Chowchilla Subbasin GSP
Advisory Committee
GSP Revisions

July 6, 2022

RE: Incomplete Determination of the 2020 Chowchilla Subbasin Groundwater Sustainability Plan

DWR Stated Deficiencies – GW Levels A.1.ii

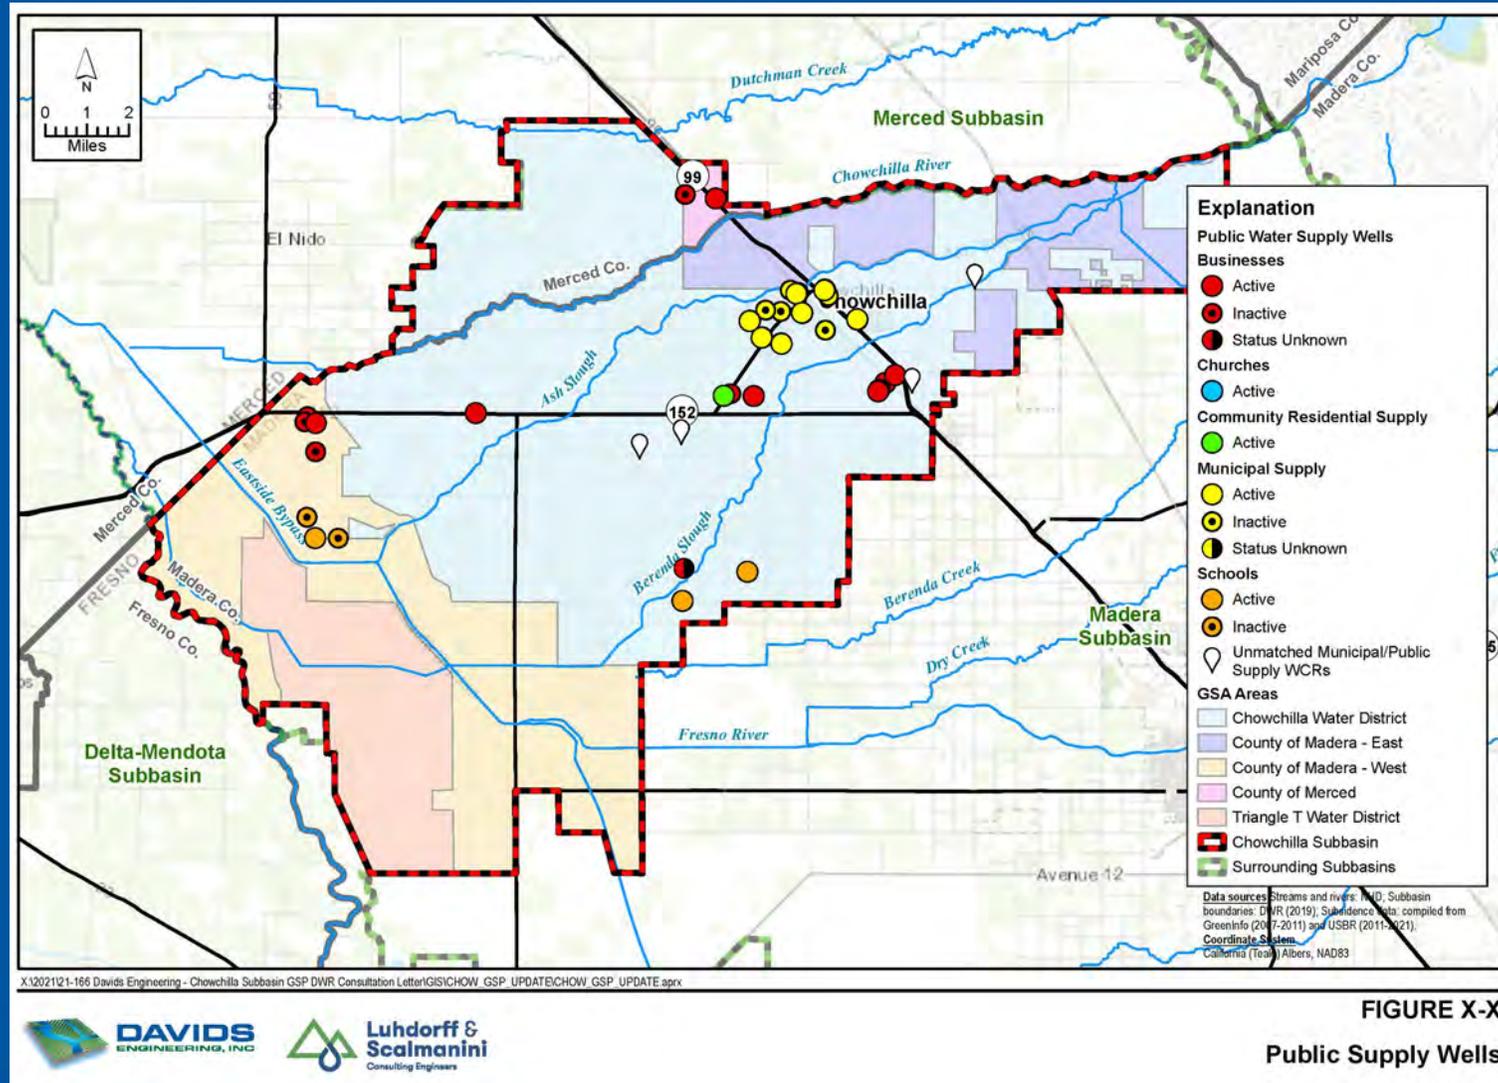
A.1.i. The GSP does not describe when the Potential Domestic Well Mitigation Program will be implemented and financed by the GSAs in the Subbasin, or how rapidly the GSAs will be able to respond to developing domestic well impacts. Absent this information, Department staff cannot evaluate whether the sustainable management criteria for groundwater levels are reasonable and will avoid undesirable results.

DWR Stated Deficiencies – Subsidence A.2.iii

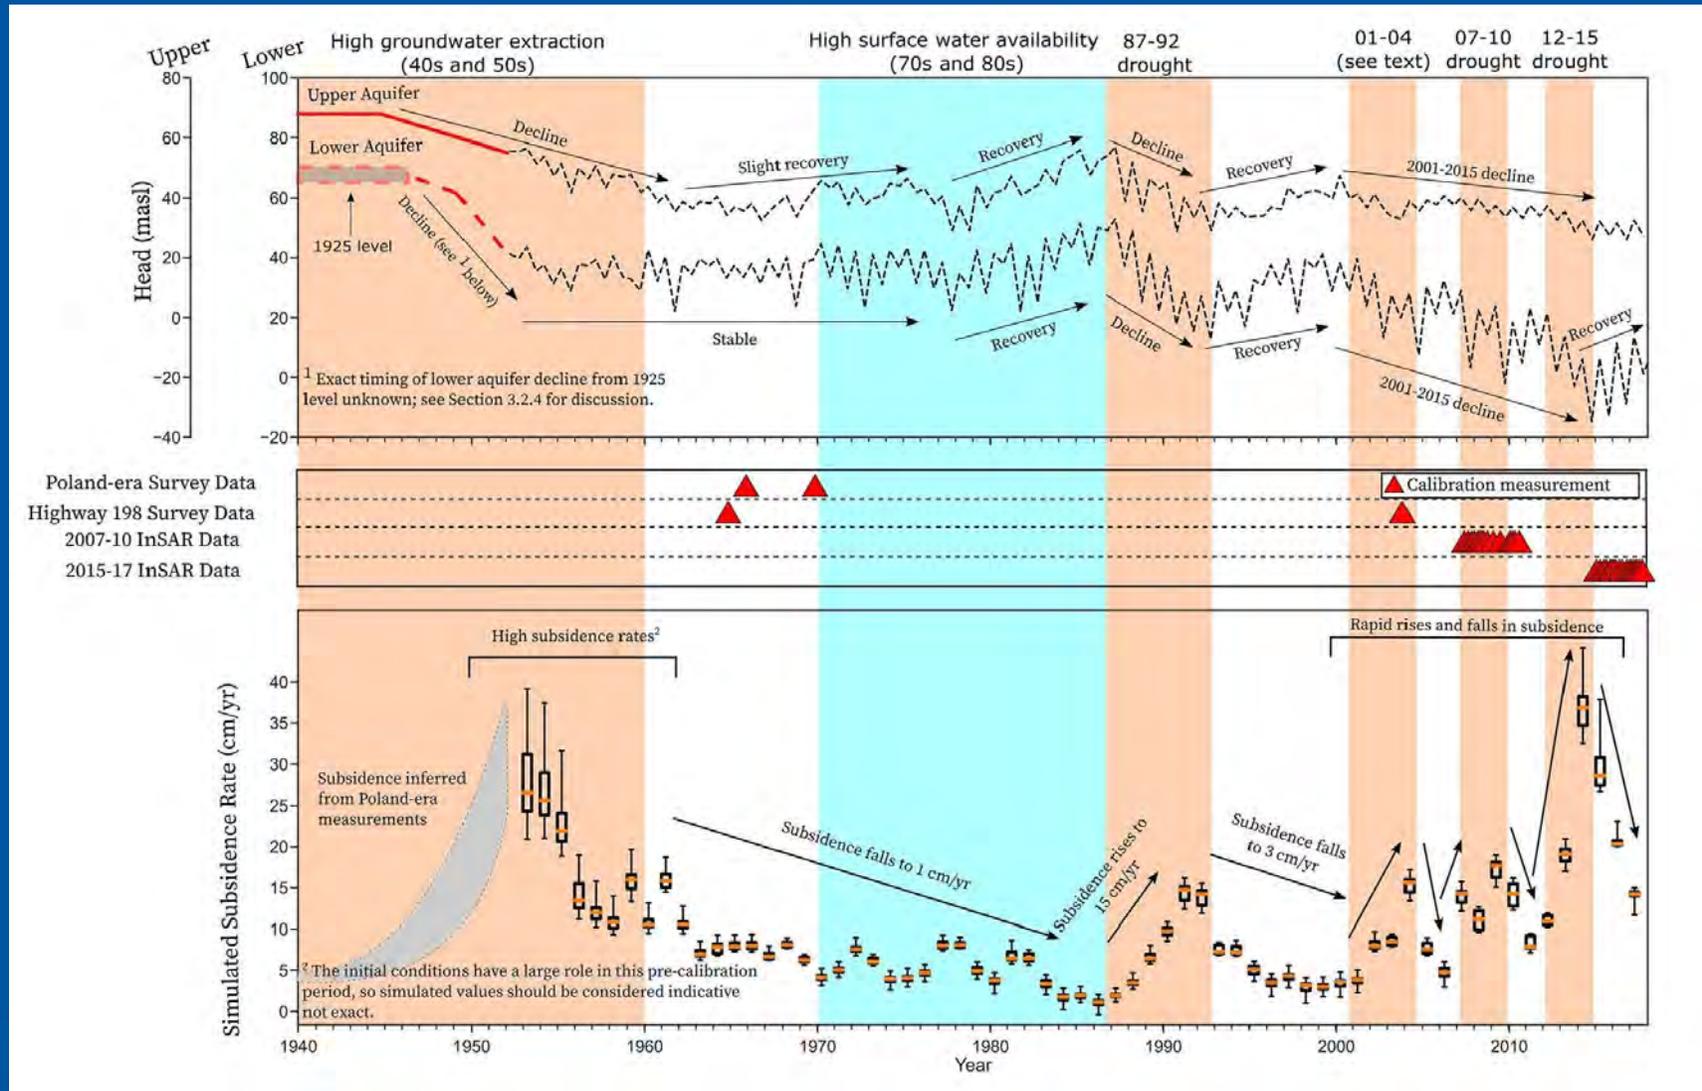
A.2.iii. The GSP allows for continued land subsidence in the Eastern Management Area, which does not reflect the intent of SGMA that subsidence be avoided or minimized once sustainability is achieved. The GSP does not explain how implementation of the projects and management actions is consistent both with achieving the long-term avoidance or minimization of subsidence and with not exceeding the tolerable amount of cumulative subsidence.

Additions to HCM/SMC Sections

- Comparison of time-series for GWLs and subsidence
 - Relationship varies; subsidence occurs at several locations with decreasing, stable, and increasing groundwater levels
 - Above relationships and lack of consistent trends likely due to occurrence of residual subsidence
- Extensive literature review regarding residual subsidence
 - Residual subsidence is a major factor in ongoing subsidence
 - Likely to be increasing over time with repeated cycles of new GWL lows
 - Likely to continue for many years/decades even with stable/recovering GWLs
- More detailed assessment of infrastructure susceptible to subsidence (identification/characterization of critical infrastructure)

DWR Stated Deficiencies – ISW B.1

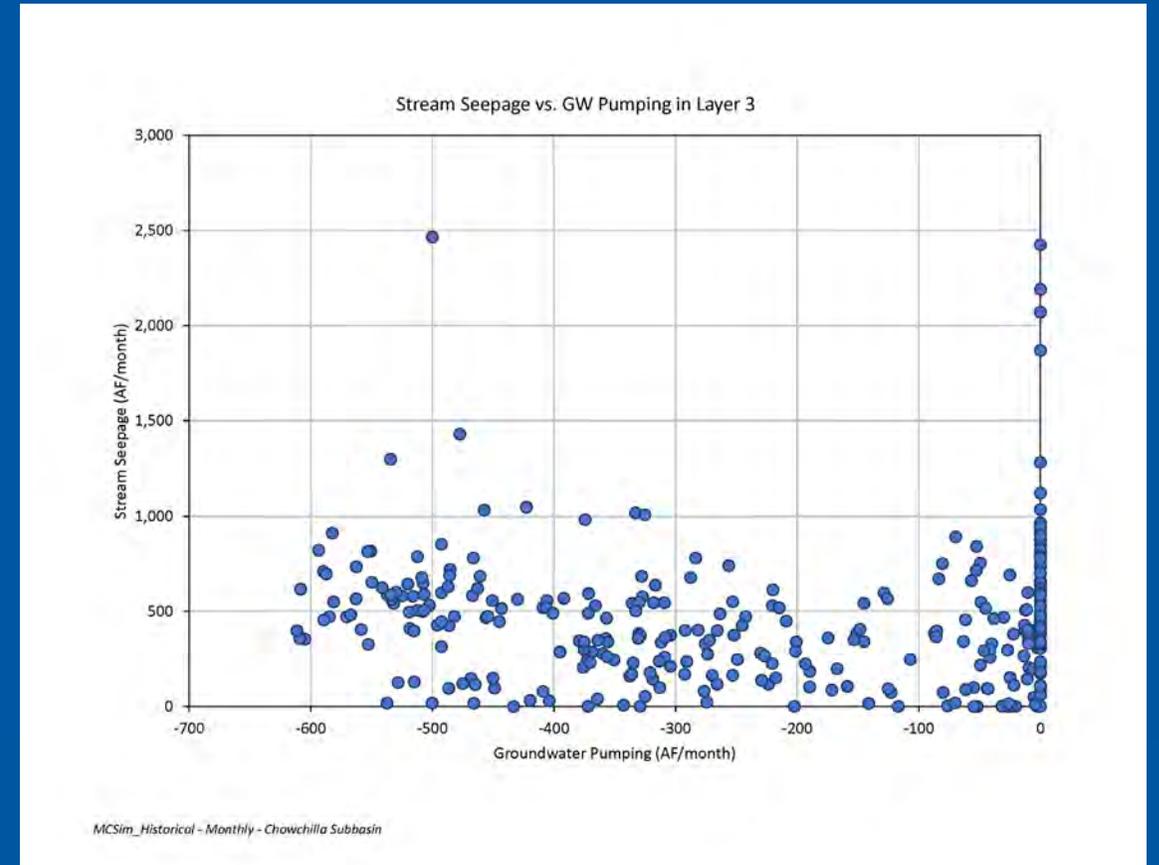
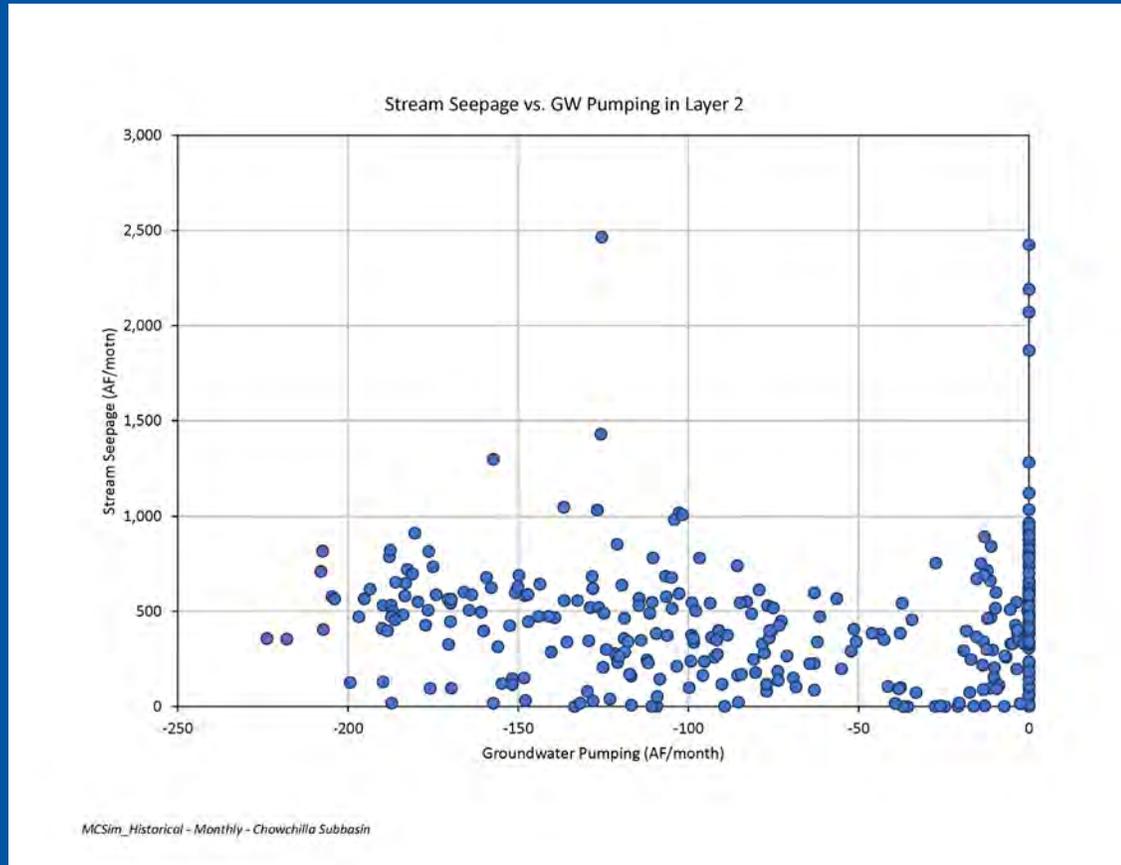
B. The GSAs do not sufficiently demonstrate that interconnected surface water or undesirable results related to depletions of interconnected surface water are not present and are not likely to occur in the Subbasin.

1. The GSP does not provide a clear and comprehensive analysis of the potential for interconnected surface water to be present along the San Joaquin River in the Subbasin.
